The Columbia Architectural Design Review Team will meet on Tuesday, July 11, 2023 at 9:00 AM in Conference Room A on the basement level of City Hall, 700 N. Garden Street. The Planning Commission will consider the following:

ART 23-0199

The applicant is requesting façade approval for two new buildings proposed within the Beechcroft Plaza Planned Unit Development. The PUD-MU design standards are applicable. The proposed structure is a one story Commercial building (Zoning Ordinance Table 4.3.8.B, p. 216) with a Shopfront frontage (Table 4.3.7.A, p.203). The application does not indicate frontage type, but it appears to most closely match the Shopfront. The PUD-MU standards prescribe a minimum two story building height. The application depicts single story structures. Presumably the applicant will ask Planning Commission to approve a deviation from this standard as part of the revised PUD Master Plan. The applicant has provided floor plans and a site plan in addition to building elevations.

CITY OF COLUMBIA TENNESSEE ARCHITECTURAL DESIGN REVIEW STAFF REPORT

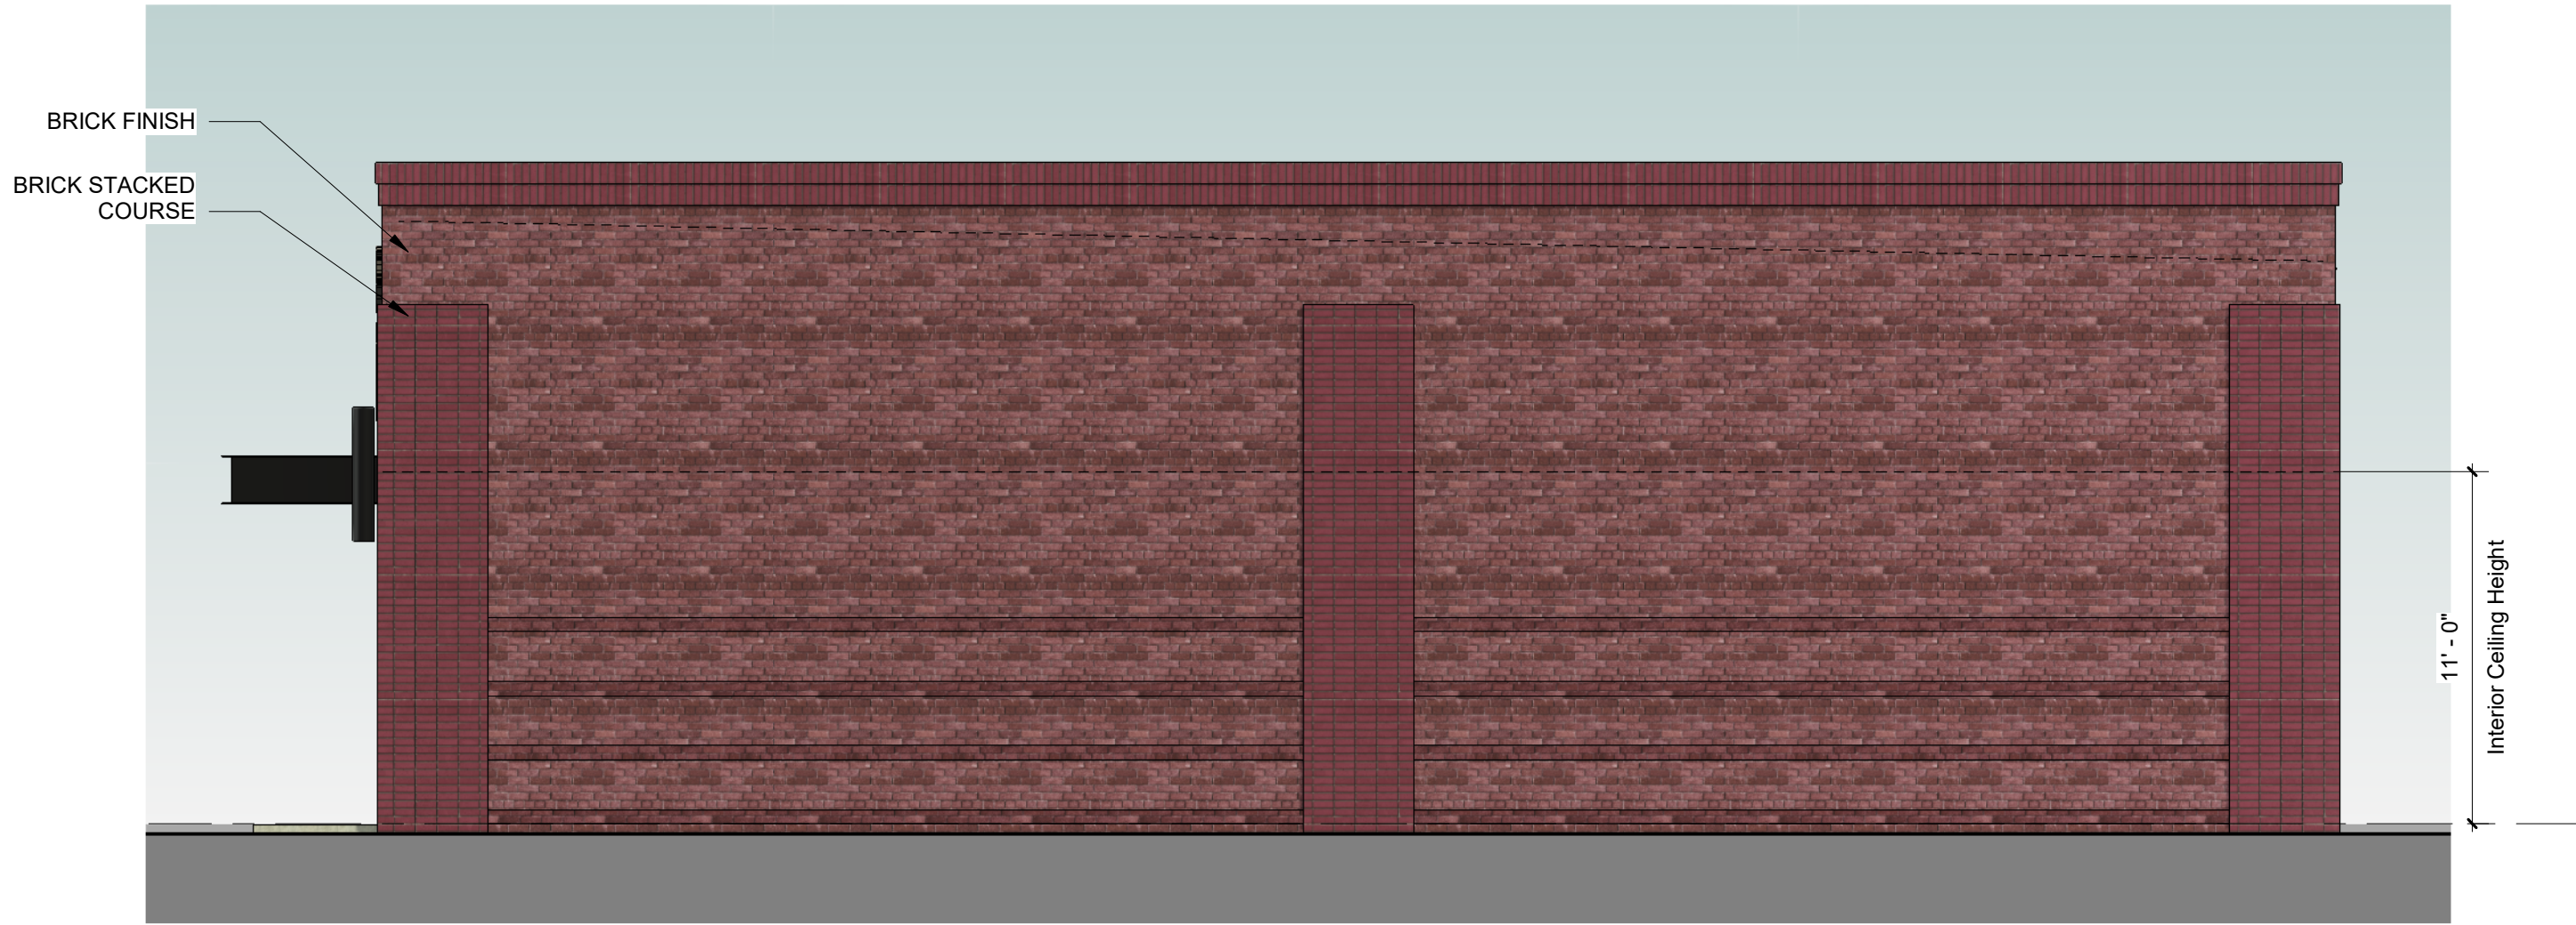
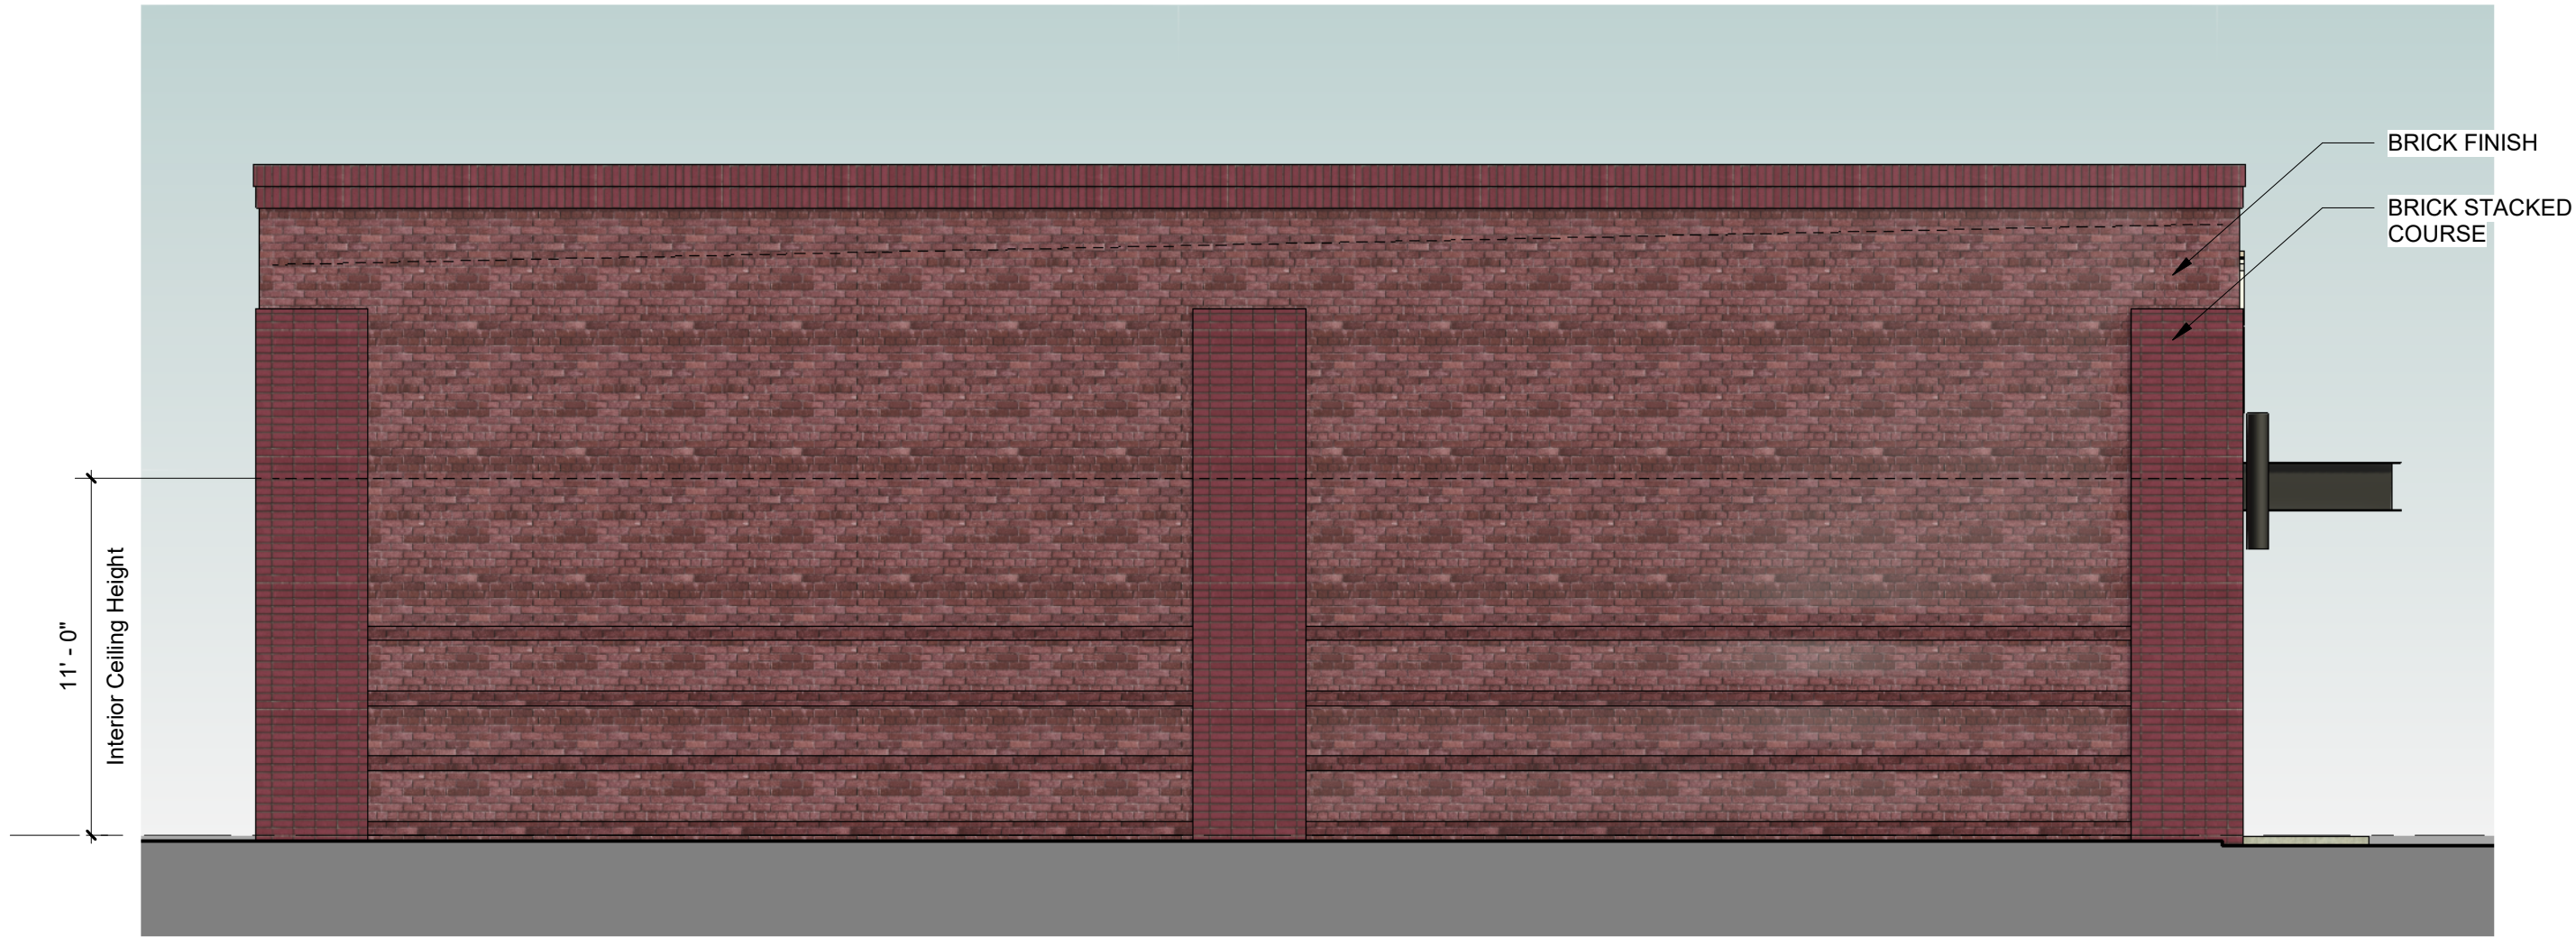
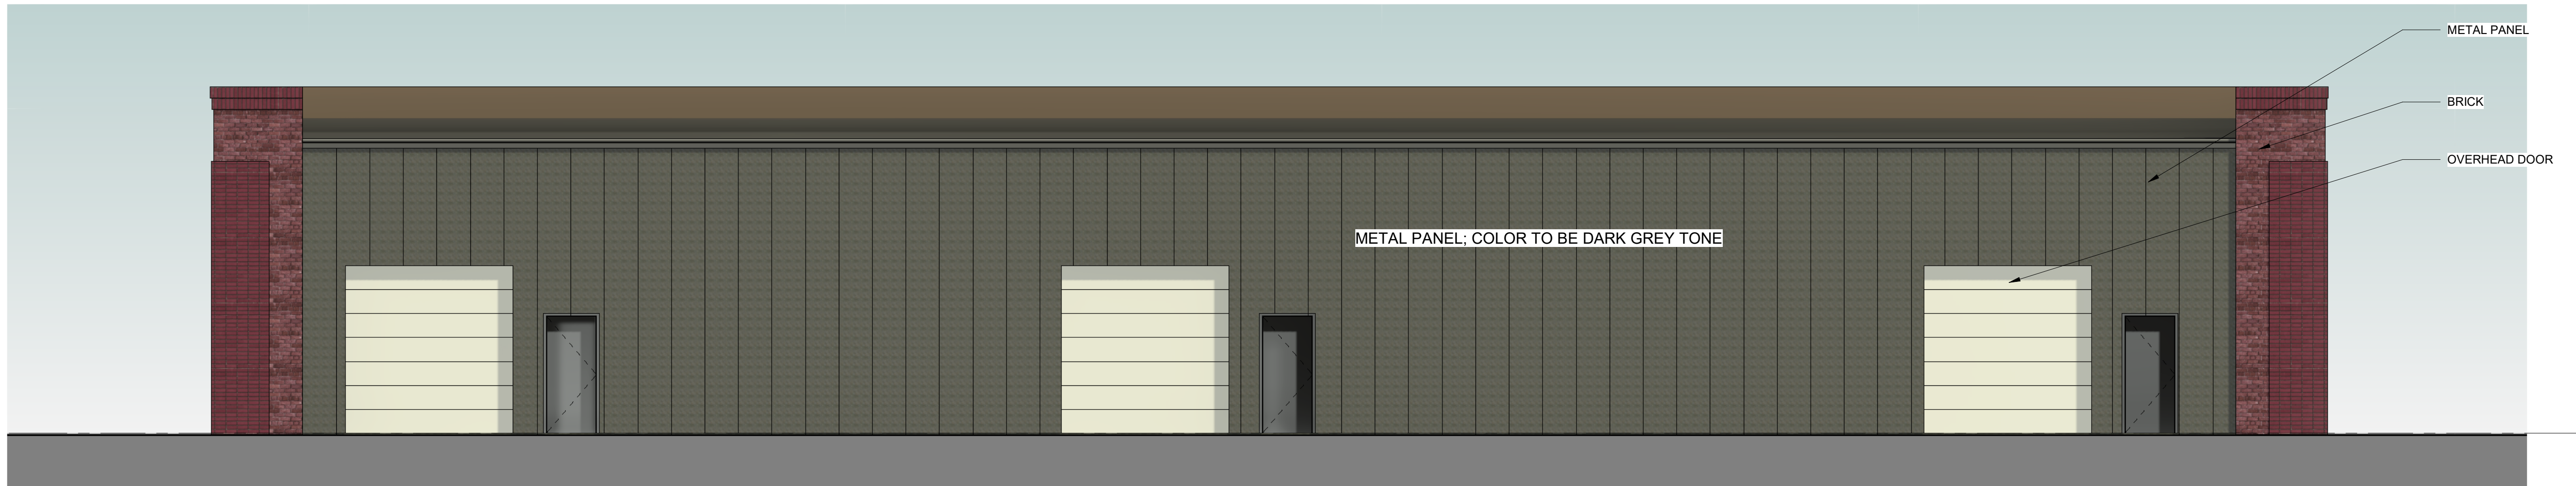
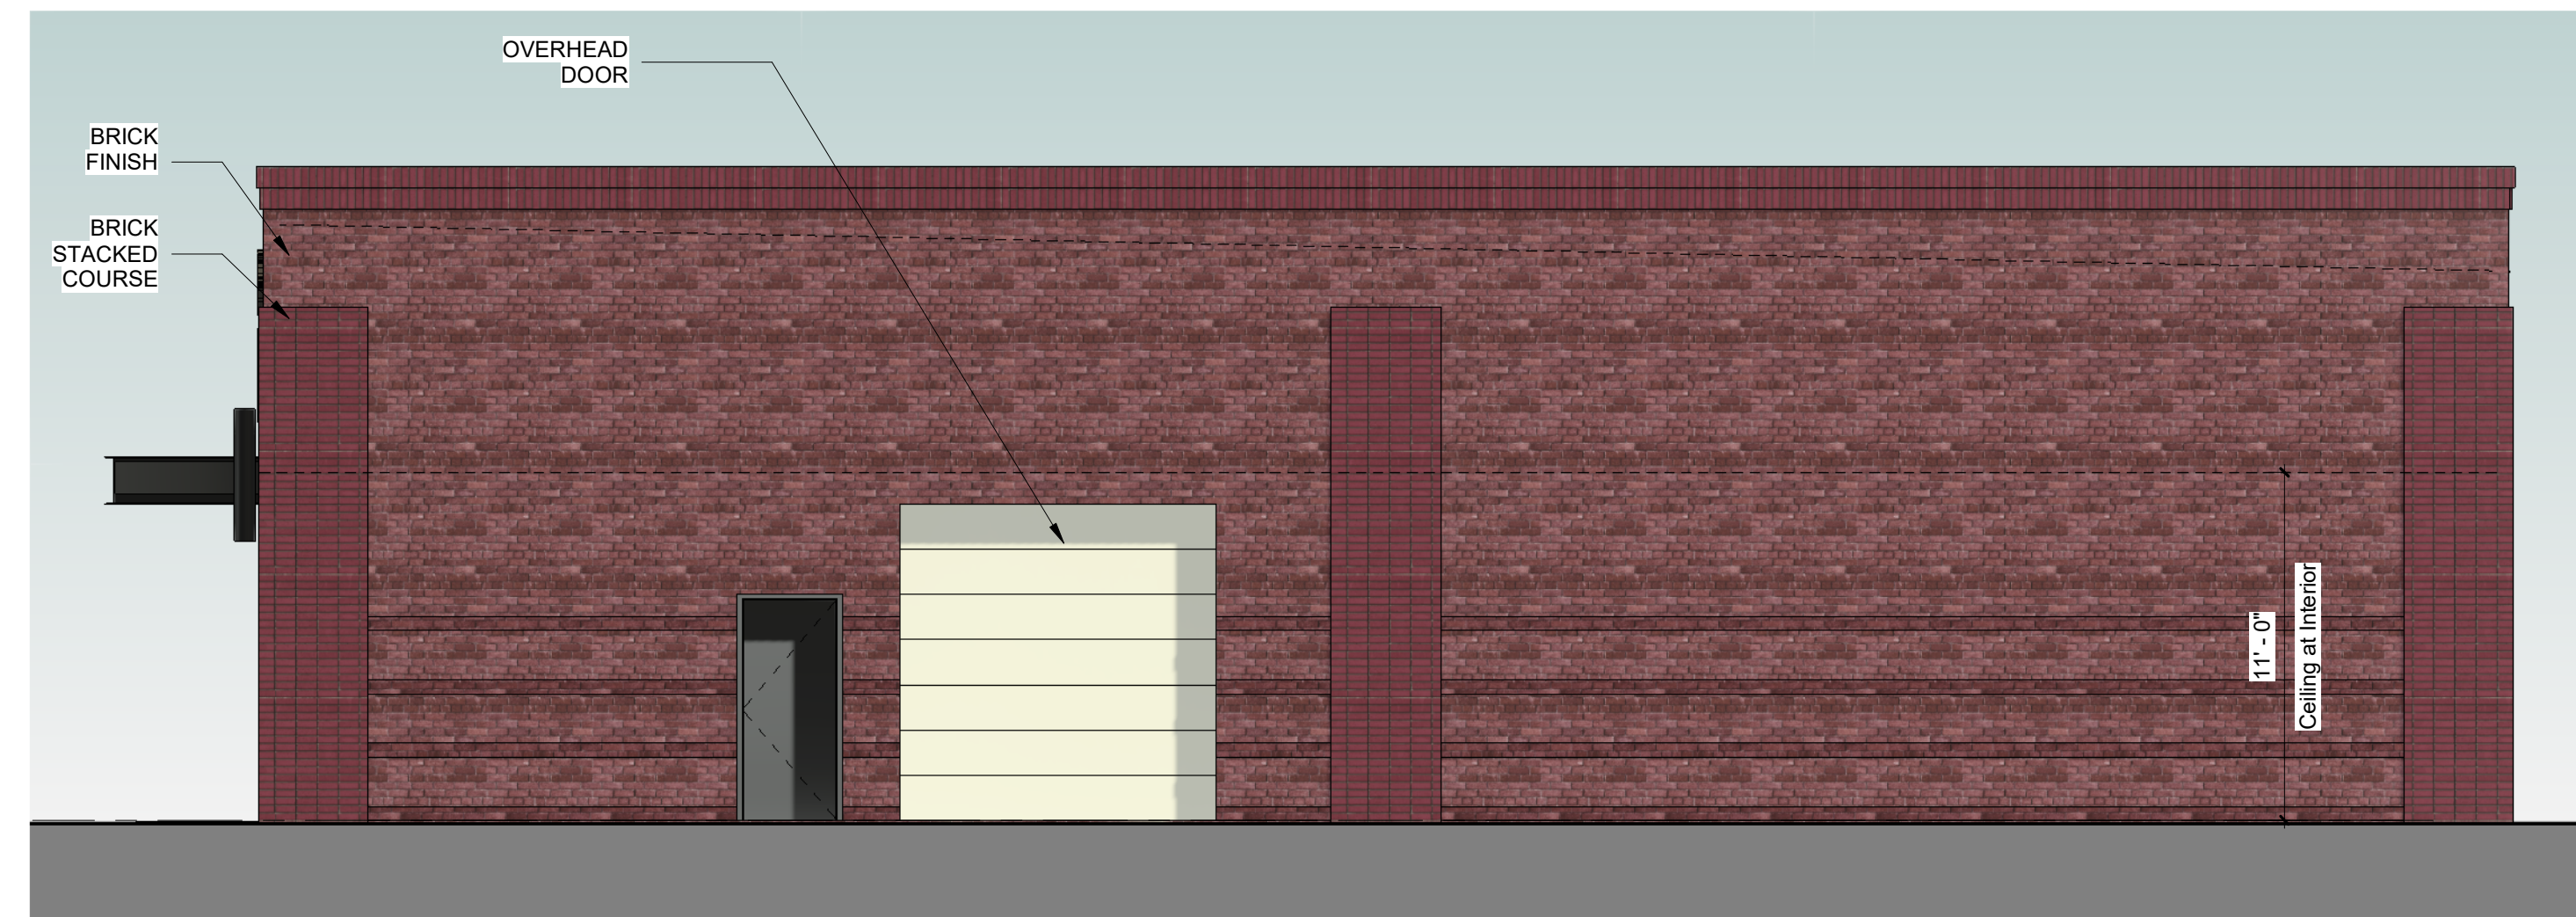
- Primary building materials on the proposed front elevations consist of brick, which is a permitted primary material for Facades in a PUD-MU.
- Rear and side elevation are metal panel siding. Primary façade materials must continue through the second layer and transitions must occur at changes in form, structure, or massing. The material changes occur beyond the corners of the structure and should be at least 20 feet beyond the façade. It is preferable for the building to completely omit the metal panel siding, especially of the side elevations.

- The Façade width is greater than 100 feet. Façade articulation is provided by partial brick pilasters.
- The Ordinance requires a ceiling height of 11 feet. The design appears to provide this ceiling height.
- The Facades of the two proposed structures are aesthetically similar but satisfy the requirement for façade variety.
- The building utilizes no more than three colors as prescribed by the ordinance.
- The proposed structures utilize a flat roof, which is permitted.
- The proposed Façade elevation does not include a knee wall. The Zoning Ordinance requires this feature is required for PUD-MU shopfronts.
- The PUD-MU standards require 70% for Shopfront frontages (20% - 60% for other frontage types). The proposed building appears to provide no more than 20% glazing.

- That the side elevations be brick rather than metal;
- The applicant confirms the finished ceiling height;
- That the glazing increase; and
- That the applicant add a knee wall to the façade.
